MEMORANDUM

From:	Built Heritage Officer		
Service	Green Infrastructure	App No:	252252 + 252253
Address:	L'Ortolan Restaurant, Church Lane, Shinfield, RG2 9BY		
Proposal:	252252: Householder application for the proposed erection of a rooftop extension with terrace decking to the existing main building, alongside alterations to the fenestration; the erection of a rooftop infill extension to the annex building; the erection of a detached single-storey garage with dual-pitched tiled roof and facing brickwork and stone/render to match the main dwelling; landscaping and parking alterations; and the demolition of the existing single- storey rear kitchen/service extension 252253: Listed Building Consent for the proposed erection of a rooftop extension with terrace decking to the existing main building, alongside changes to fenestration; erection of a rooftop infill extension to the annex building; erection of a detached single storey garage with dual pitched tiled roof and facing brickwork and stone/render to match the main dwelling; landscaping and parking alterations; following demolition of existing single storey rear extension.

Summary Of Recommendations

Extracts from proposed ground floorplan, drawing P11 Rev.A of 252252.

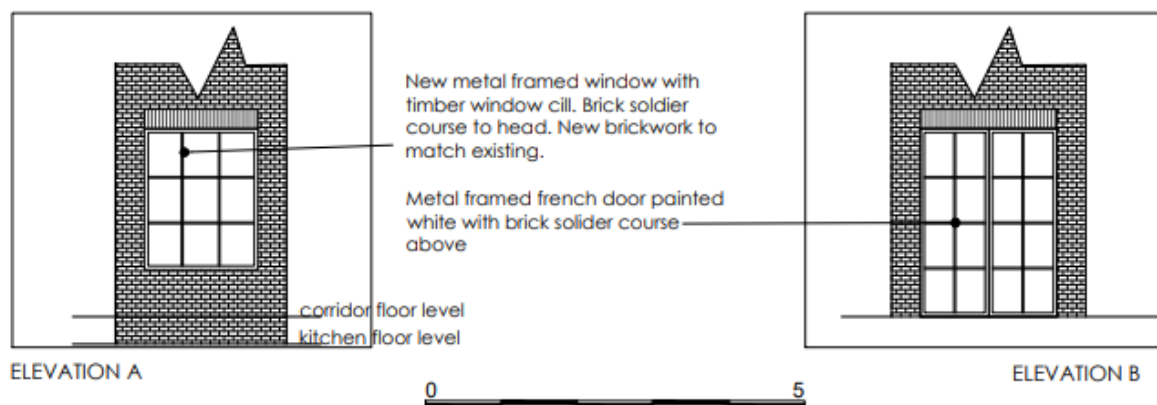
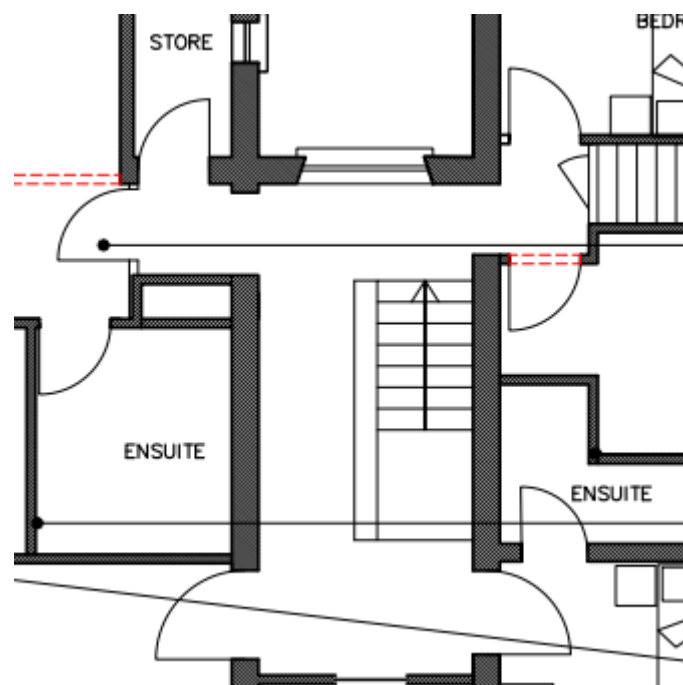
- Noted changes to the form and size the window/openings to the enclosed courtyard, what reason for the changes?
- On the application drawings, the front door is hung off the opposite side to that of the approved plans which show the glazed entrance lobby screen retained but is now shown to be removed. Would wish clarification as to the reason for the changes?
- Changes made to the layout of the utility boot room to that already approved. No justification provided for the changes.

Extract from proposed first-floor plan, drawing P12 of 252252.

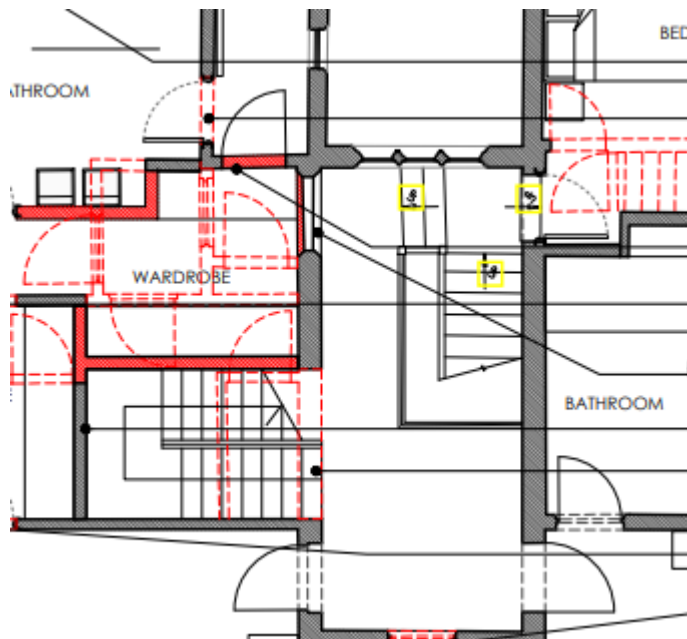
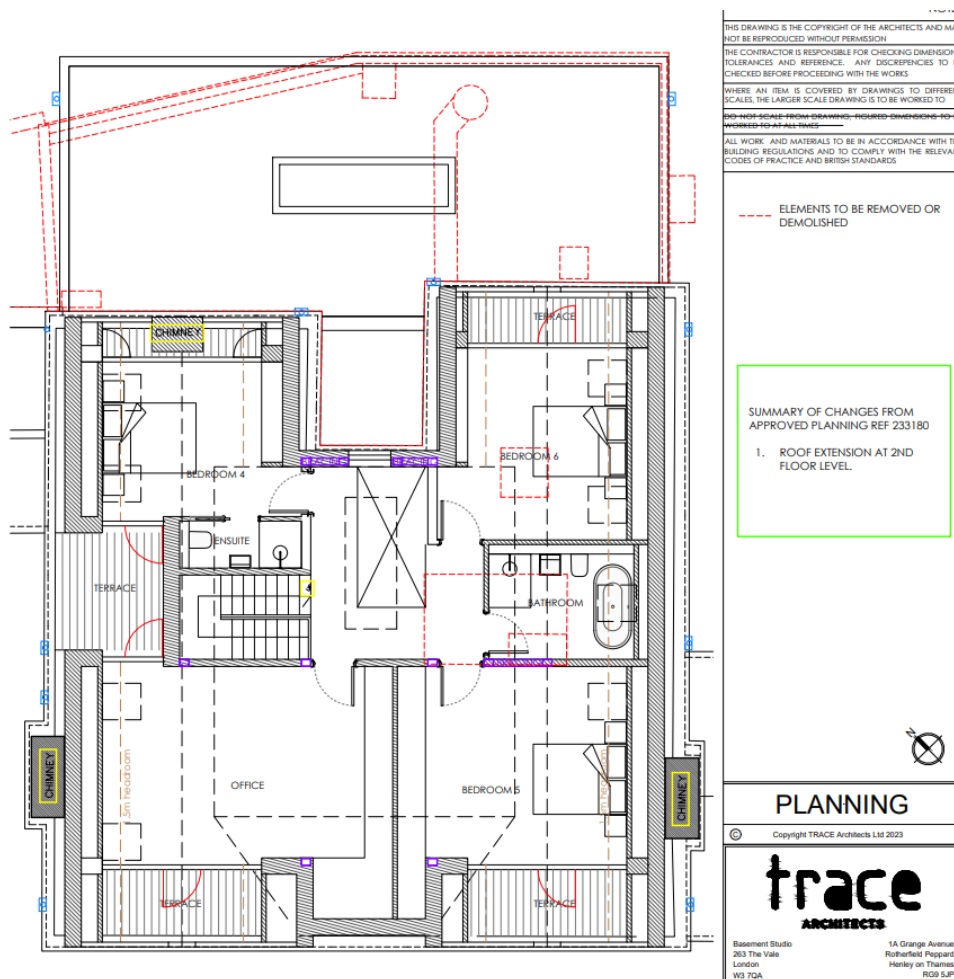
- Not clear on the above plans the reason for the difference to the stairs (additional steps, form) and landing stairwell?
-

Extracts from approved proposed attic floor plan, drawing P13 rev A of 252252.

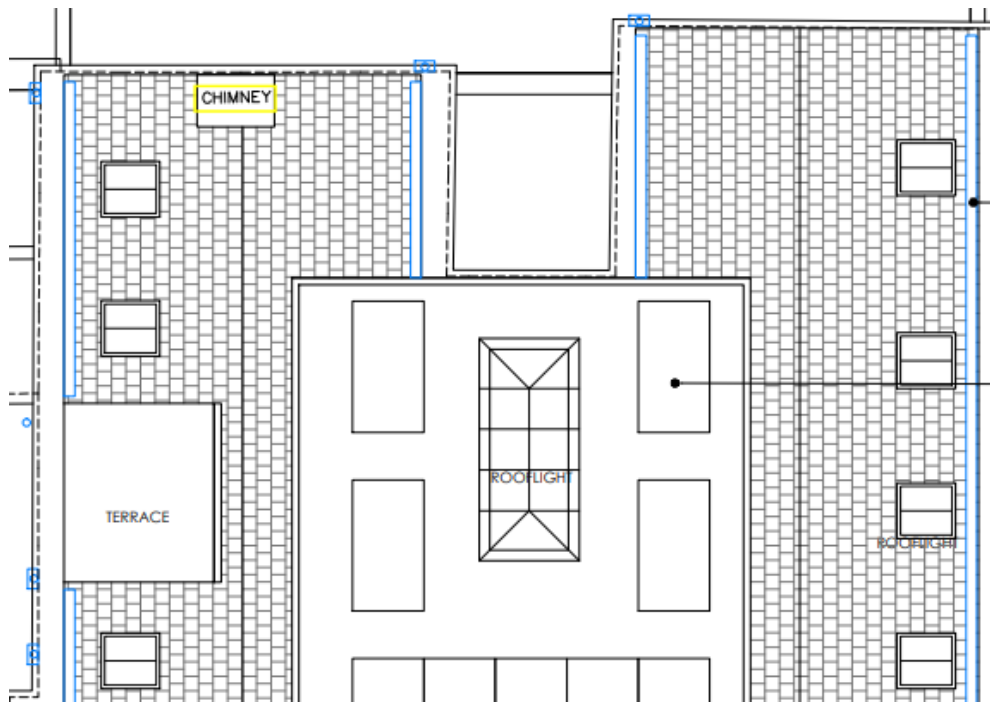
Also, it is worth mentioning here that with respect to the proposed attic floor plan (drawing P13 rev A of 252252) what the internally diagonally crossed rectangular detail is intended to represent as it is suggestive of an opening through to the first floor above the main staircase. As such clarification is requested with respect to that detail

- Not clear on the above plan what the blacked lined rectangular shape, with diagonally drawn line within, is meant to represent?

Extracts from proposed roof plan, drawing P14 rev A of 252252.

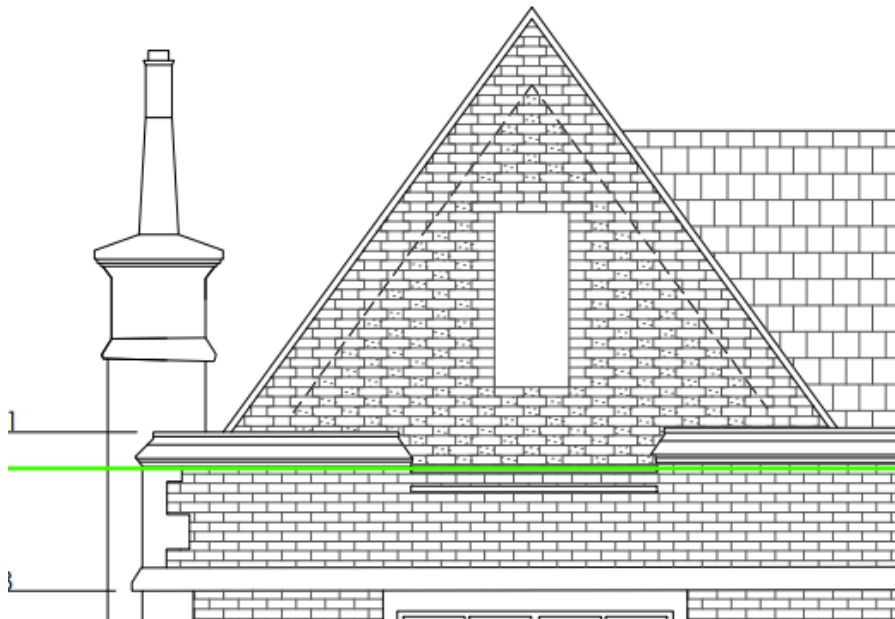
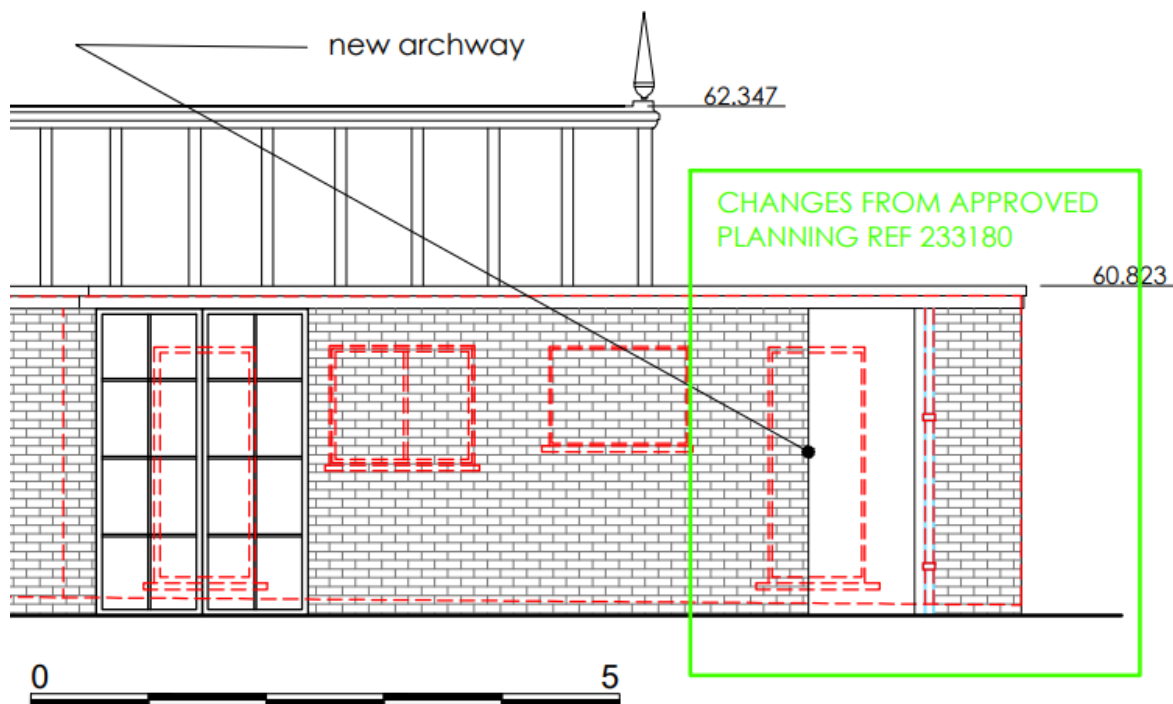
- Question is how rainwater run off to roof by the terrace cut out is to be handled?

Extracts from proposed elevation plans, drawing P15 rev A of 252252 showing flat topped new archway opening.

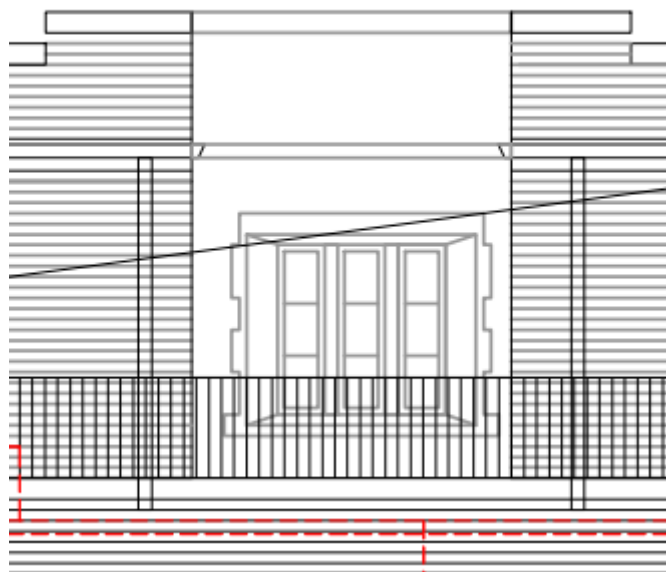
- Would question how the flat-topped archway is to be formed, so as to have the stone banding/coping carried over it?
- The form and potentially position of the previously approved new French door opening appears change on the application drawings.

Extract from proposed elevation plans, drawing P15 rev A of 252252. of rear window to staircase.

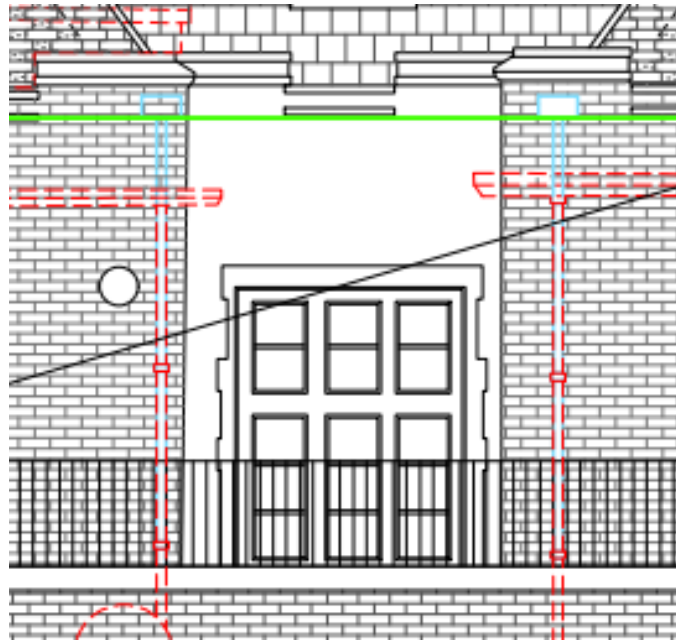
- Explanation need for the notable difference in the rear first-floor window to the staircase and the parapet wall crenulation detail from that of the approved drawings and those now being proposed?

- Clarification is required concerning the rainwater hoppers and down pipes/ The blue outlines appear to represent new rainwater hoppers set higher up on the parapet brick (for the new roof rainwater channels) and the red-dashed lines represent the existing rainwater element to be removed. However, it is not at all clear on the drawings the apparent intention for new downpipes in the same location as the existing.

- Not clear what the white infilled circle on the rear brickwork elevation to the left of the staircase window is? Photos would appear to suggest an existing flue presumably related to the former teaching kitchen in the rear first -floor room. If now redundant flue would argue it be removed.
